**WRITTEN REPRESENTATIONS REGARDING THE APPLICATION BY SUFFOLK
COUNTY COUNCIL FOR AN ORDER GRANTING DEVELOPMENT CONSENT FOR THE
LAKE LOTHING THIRD CROSSING**

PLANNING INSPECTORATE REFERENCE NUMBER TR010023

**IMPACT OF LAKE LOTHING THIRD CROSSING
ON NEXEN ACCESS AND OPERATIONS**

1069648-WSP-HML-LL-DR-CH-0101

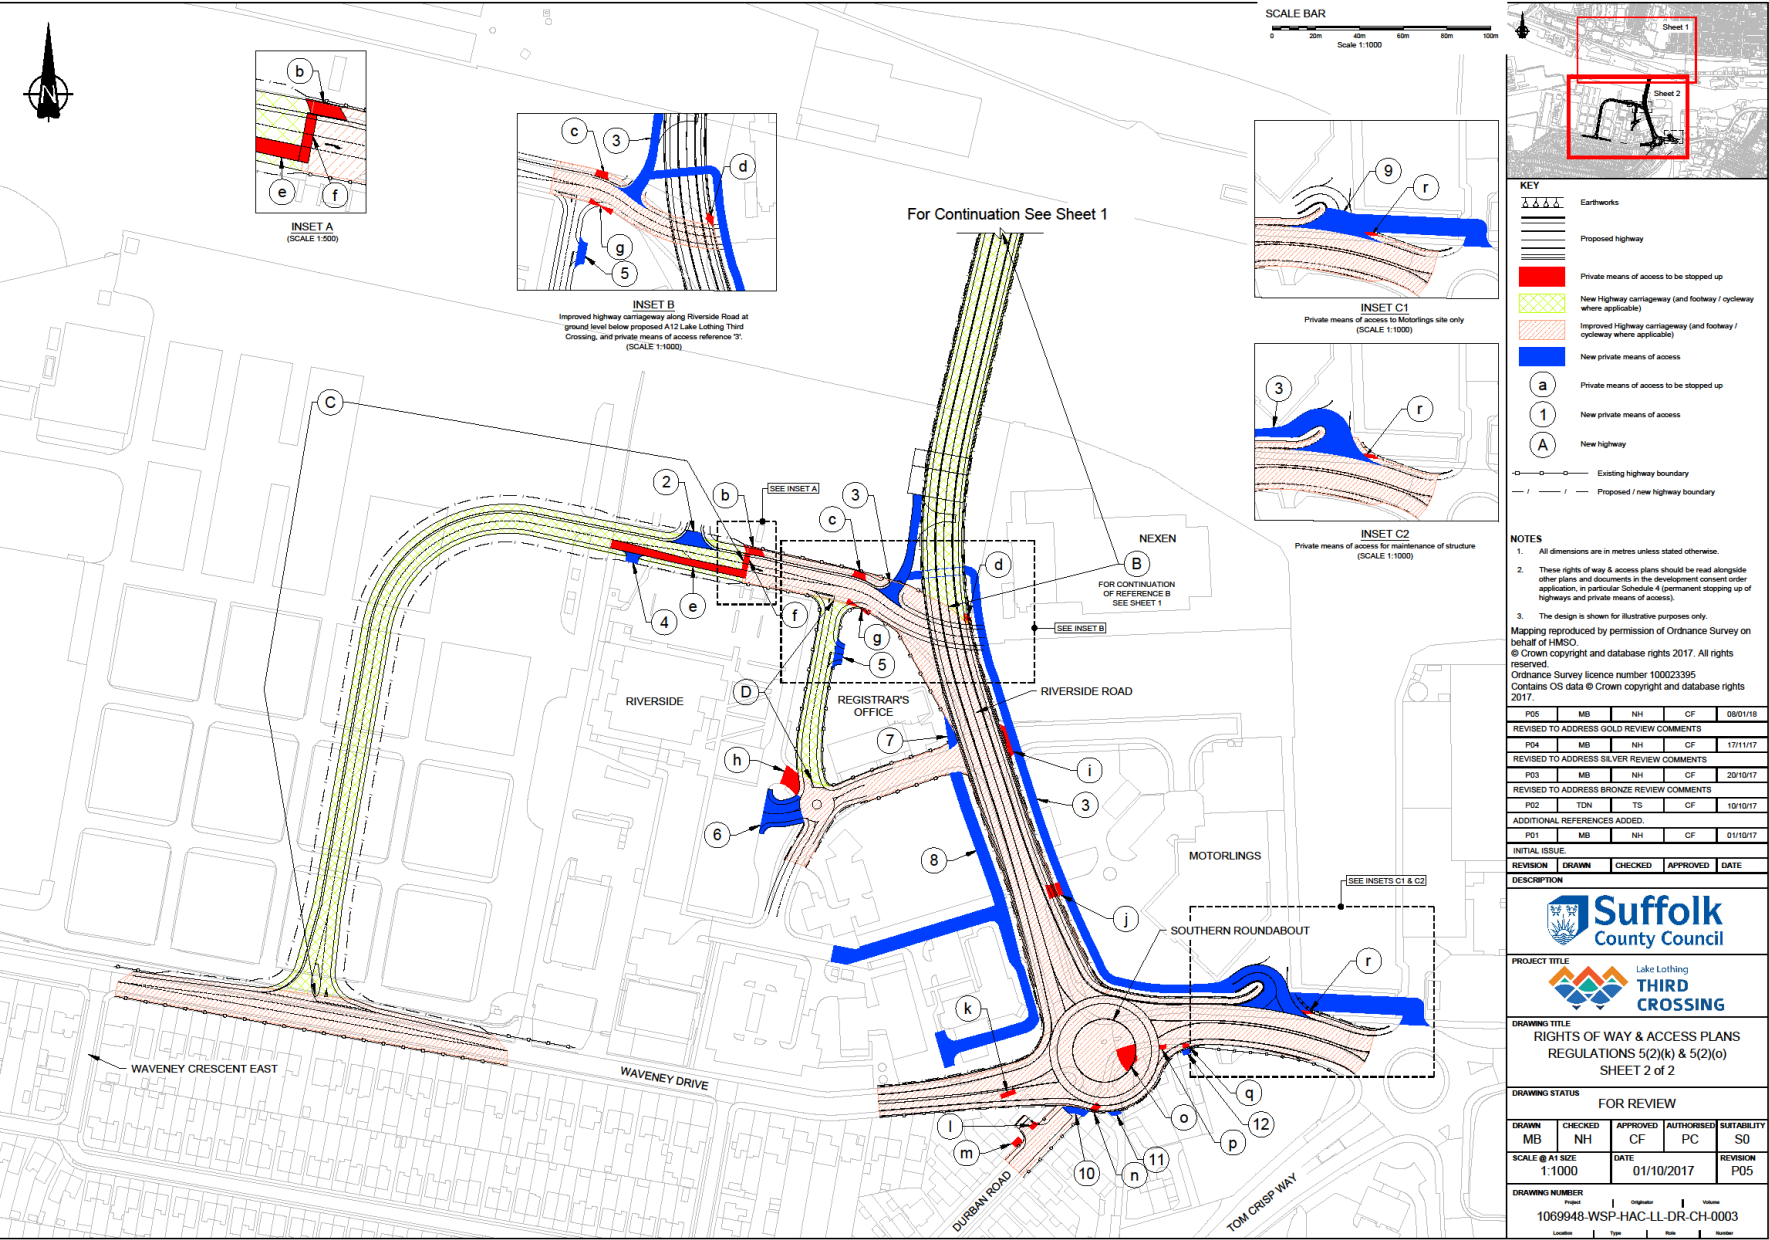
4.1 A detailed assessment of the horizontal (plan) and vertical geometry of the SCC published scheme of the LLTC is provided at *Appendix B*. This assessment is based upon the information provided on SCC drawing, 1069948-WSP-HML-LL-DR-CH-0101, rev P02 (*see Appendix A*).

4.13 The alignment geometry of the northern and southern roundabouts is provided on the drawings in plan only (horizontal geometry).

- 4.15 The 'deflection' path of traffic entering the northern roundabout from the road of the LLTC requires more detailed checking. It is apparent that an entry path radius of greater than 100m could be achieved. This would require some re-design of the plan layout to correct.

- 4.17 It is noted that SCC have not provided preliminary roundabout capacity checks linked to the design geometry; i.e. there are no Arcady / Roads 9 analyses. This analysis is required to conform that the roundabout geometry will provide the required traffic capacity.

5.4 SCC has not provided adequate or appropriate vehicle tracking analysis to illustrate how the Nexen site may continue to operate with the new access arrangement as shown on their drawing 1069948-WSP-HML-LL-DR-CH-0101, rev P02 (*see Appendix A*).

Drawing **1069948-WSP-HML-LL-DR-CH-0101**

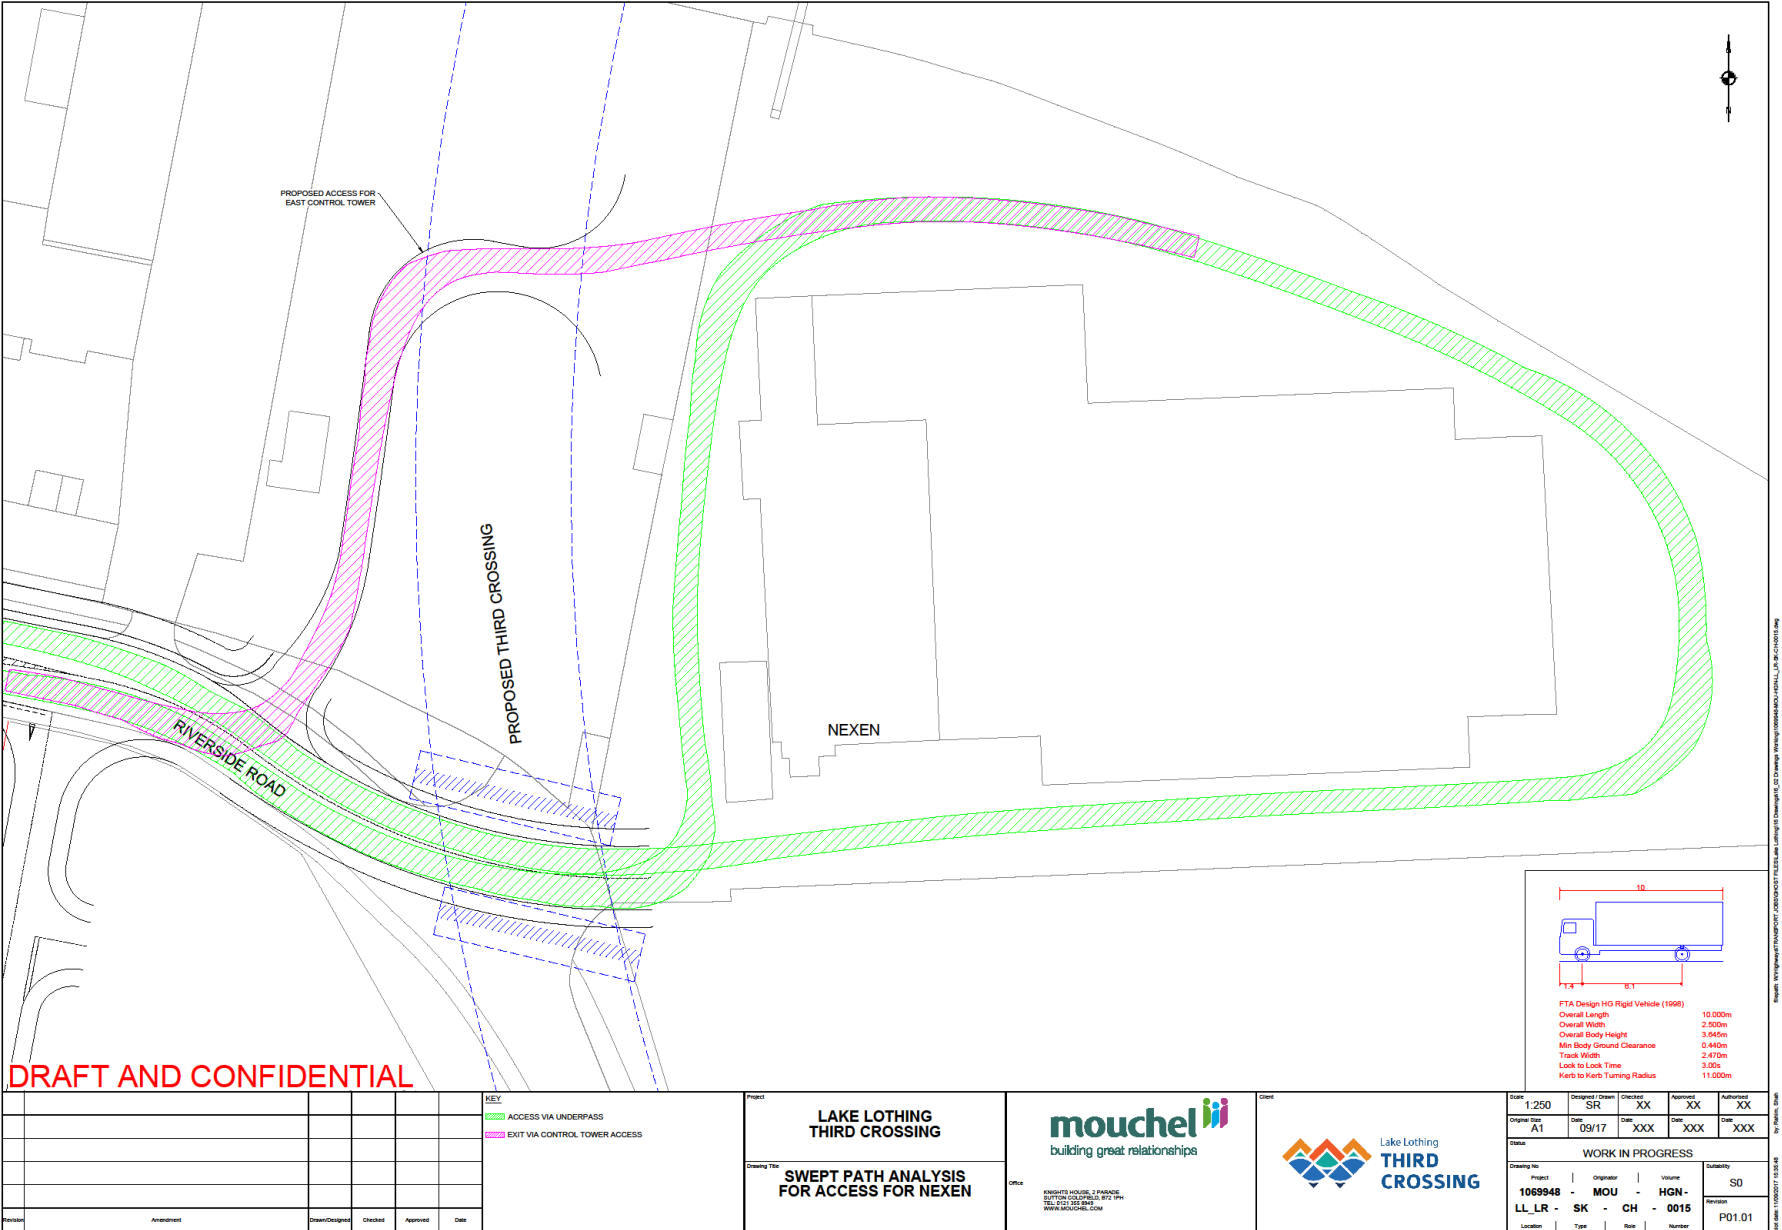
Not stated on drawing.

No indication on drawing of widening. Departure from Standard required, or scheme to be amended.

1069948-SCC-HGN-LL-DR-KK-0007	ALTERNATIVE NEXEN ACCESS OPTION 2
1069948-SCC-HGN-LL-DR-KK-0008	ALTERNATIVE NEXEN ACCESS OPTION 2 SWEPT PATH ANALYSIS
1069948-SCC-HGN-LL-DR-KK-0009	NEXEN ACCESS (BASE DESIGN) HEIGHT CLEARANCE AND SWEPT PATH ANALYSIS

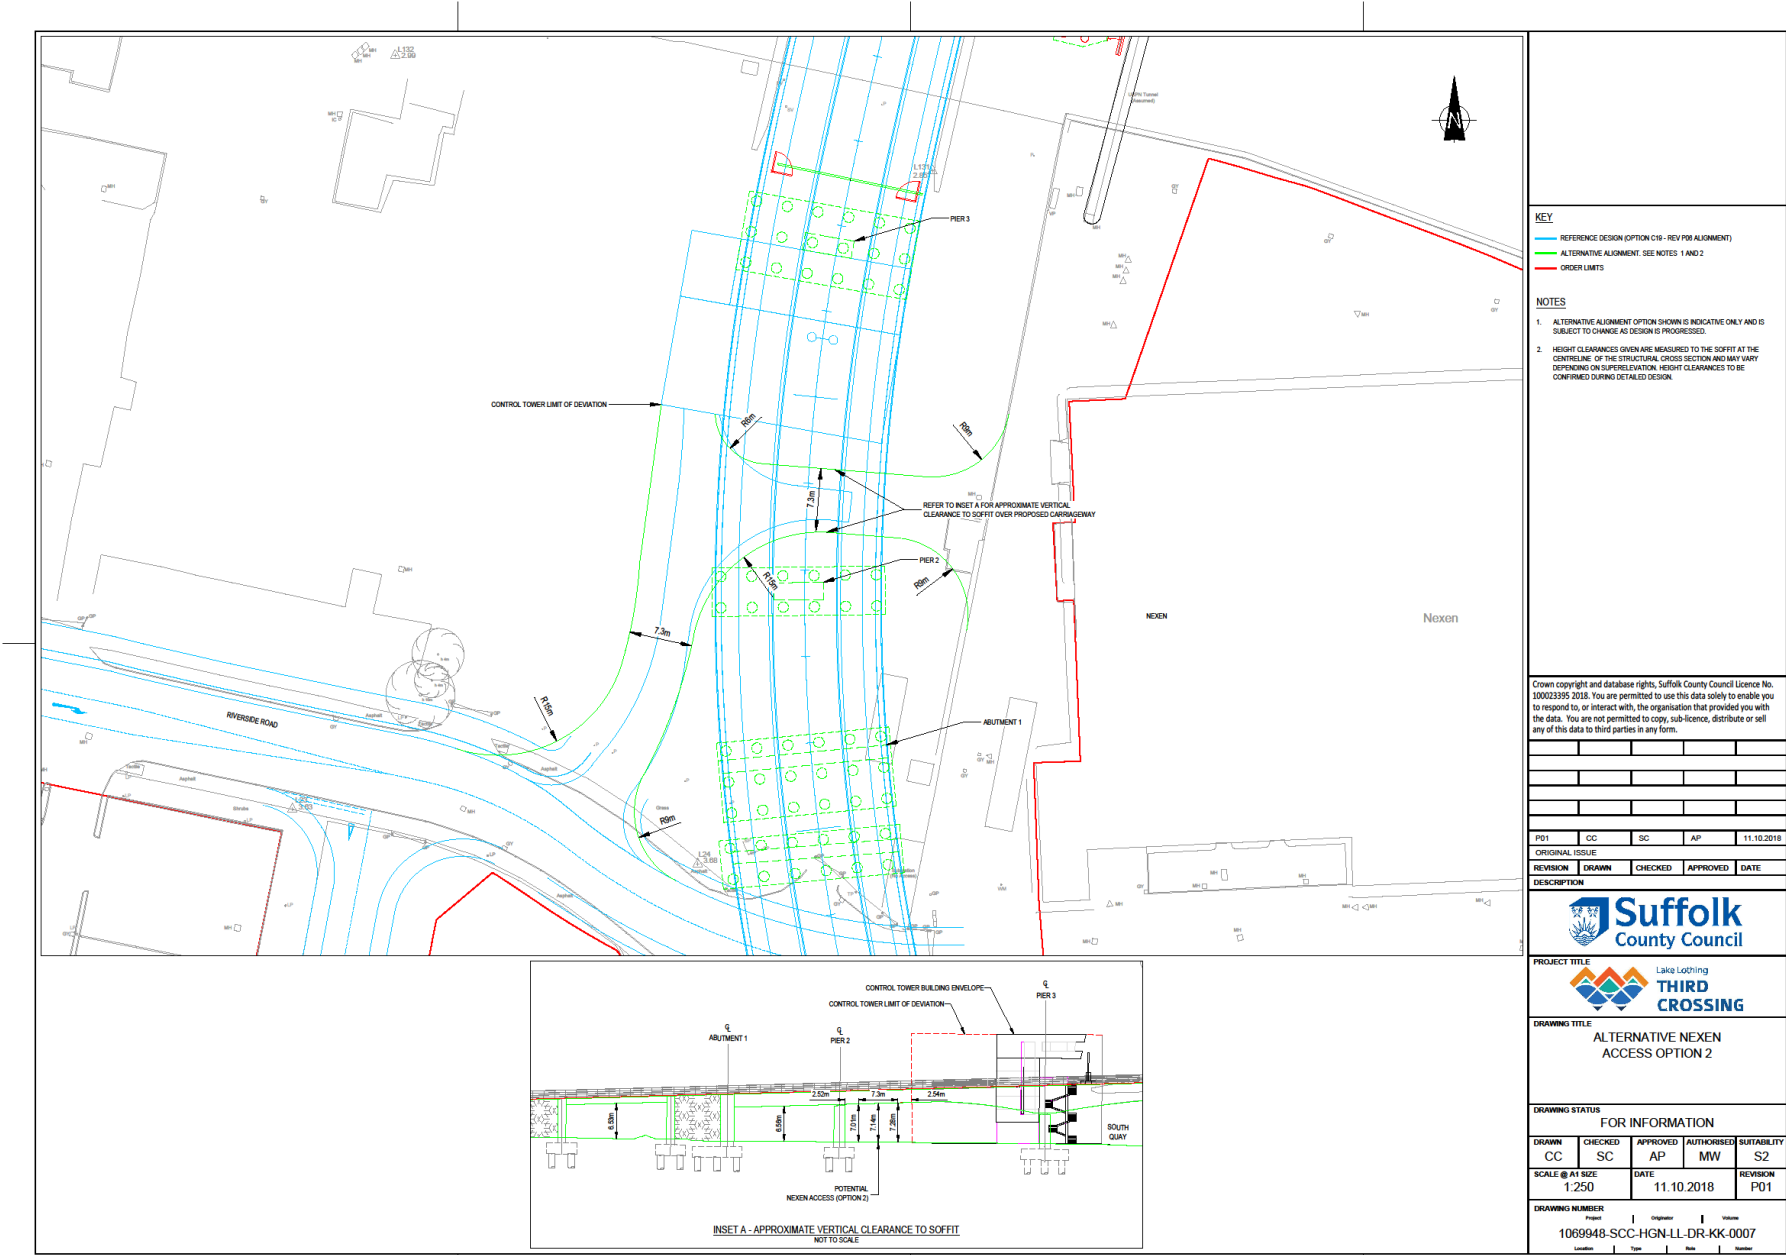
- 4.9 The LLTC Option 2 proposals (see drawing 1069948-SCC-HGN-LL-DR-KK-0007) illustrate that the headroom clearance of accesses on to Nexen site through the LLTC bridge spans have headroom clearance been increased to 6.5m (original access point) and 7.01m (new more northerly access point).

- 4.11 The LLTC Option 2 plans illustrate a new heavy goods vehicle access route on to the Nexen site (see drawing 1069948-SCC-HGN-LL-DR-KK-0007). This is provided to the north of the existing site access and approaches the flank of the Nexen warehouse / factory building. The main 'goods-inward' door for the Nexen factory is located immediately in front of the new proposed access.

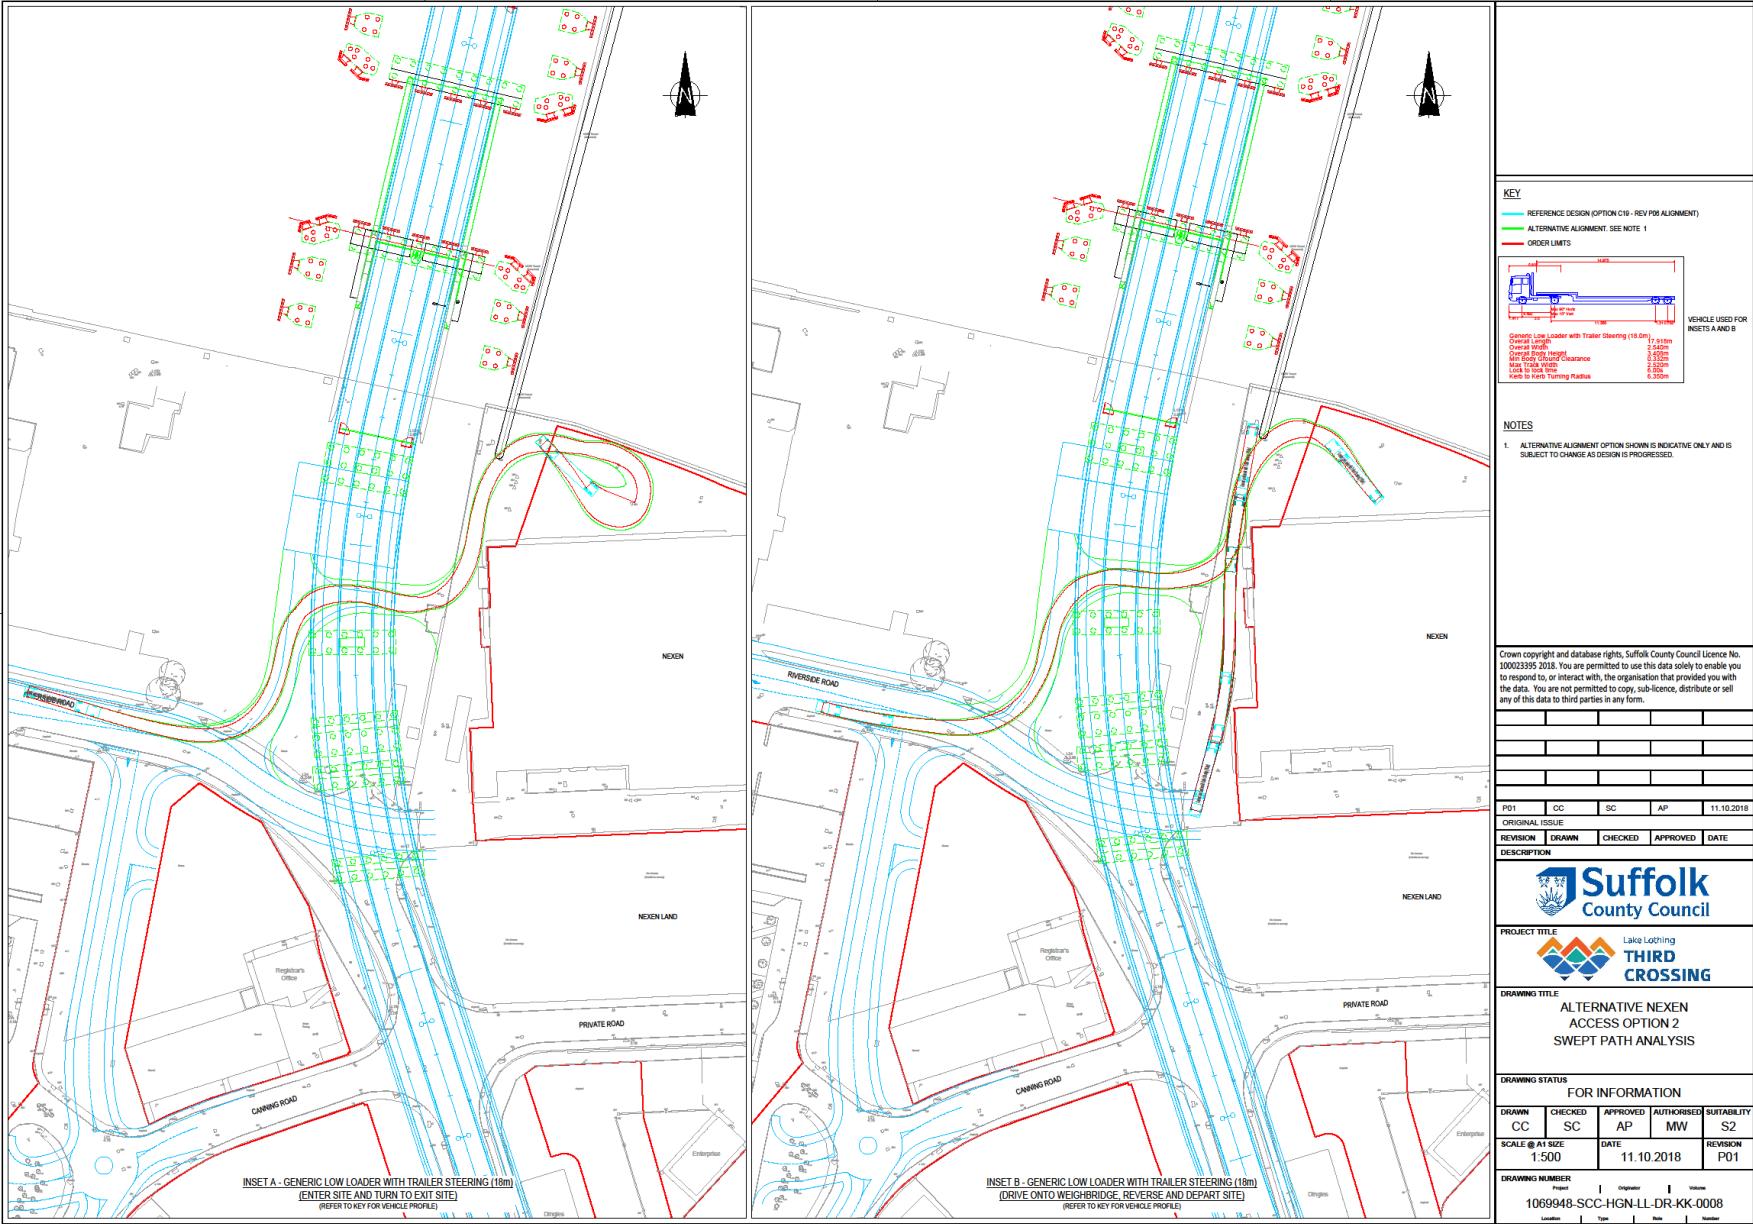
- 4.6 LLTC Option2 drawings 1069948-SCC-HGN-LL-DR-KK-0008 and -0009 (*see Appendix A*) provide swept path analyses for a low-loader vehicle entering the Nexen warehouse and factory site at two access points.

- 4.13 The swept path analysis for a low -loader using the proposed access (see drawing 1069948-SCC-HGN-LL-DR-KK-0008) illustrates that this vehicle could only enter or leave the site when another vehicle is not already at the goods inward door. Based upon this drawing and relative vehicle sizes, it is apparent that this situation will be repeated for any other heavy good vehicle entering or leaving the site. See also sketch MBSK 190102-1 at Appendix B.

- 4.15 Taking account of 4.13 and 4.14 above, the LLTC Option 2 access would provide a worse situation, rather than an improvement, for vehicles entering the site. Use of the new access would only be possible when the goods inward door was not in use; thereby placing a restriction on the times of operation of other vehicle users of the site.
